WICKHAM MARKET PARISH COUNCIL

Wickham Market Parish Council response to Sizewell C (SZC) stage 3 pre-application consultation

Figure 1 - Map showing Proposed alternative Route

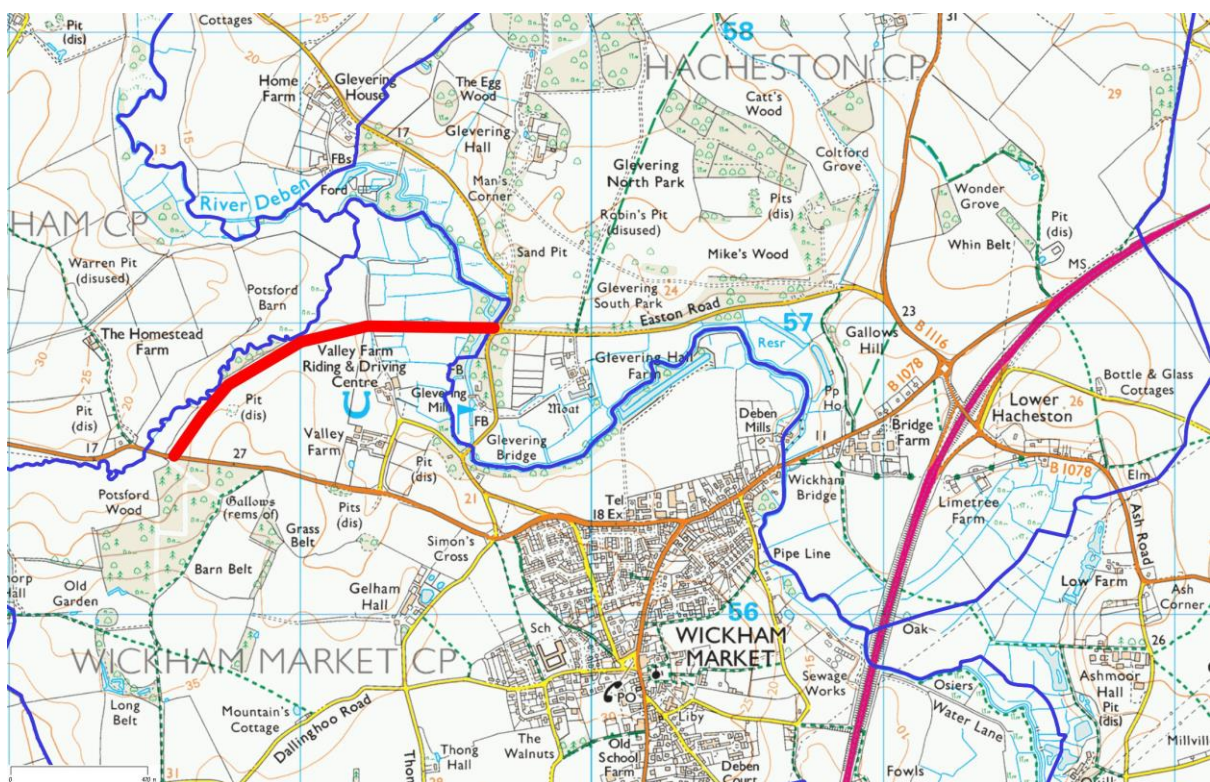
- 18.10. A possible alternative new road is shown in red below:

This alternative has the significant benefit that road users will choose this route in preference to the existing road route as it will be quicker, a better road and an easier journey. The bridge/crossing over the River Deben will not be easy as it is on a flood plain however, once built it will form an extremely positive lasting legacy for Wickham Market as it will significantly reduce current HGV traffic through the north end of Wickham Market. It is appreciated that this option is not ideal from an environmental perspective and certainly does not have universal support within the Parish Council so if EDF could propose a better diversion route then that would be ideal. Alternatively, if there are significant environmental objections, the diversion route could be temporary, thus the river valley would be returned to its natural state after the project.
